From: Matthew Kelly <mkelly@epsilonassociates.com>
Sent: Tuesday, December 13, 2022 9:00 AM
To: Building Assistant
Cc: jonathan.roberge@eversource.com; simon.hildt@eversource.com; Joshua Surette
Subject: Eversource Lines 1231-1242 Reconductor and Structure Replacement Project (MassDEP File # 142-0230) - Minor Field Change Request
Attachments: STR_25261_field_change_request.pdf; Image.jpeg; Image.jpeg

I am writing to request authorization for a minor field change from the Deerfield Conservation Commission for Eversource's Lines 1231-1242 Reconductor and Structure Replacement Project. The Deerfield Conservation Commission issued an Order of Conditions, under MassDEP File #142-0230, for the project on 7/15/2022.

LINES 1231 AND 1242 RECONDUCTOR AND STRUCTURE REPLACEMENT PROJECT
Environmental Resources Map

Structure 31011/25261:

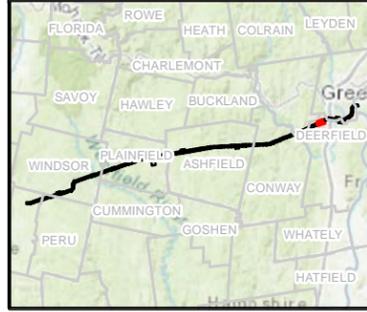
During a constructability review for the work pad at replacement structure 25261, the Eversource contractor identified an area of exposed ledge that will need to be graded in order to safely place construction mats for the work pad. The area of additional grading is depicted on the attached map page and photographs. A sediment control barrier will be installed between the work area and the adjacent wetland prior to start of construction.
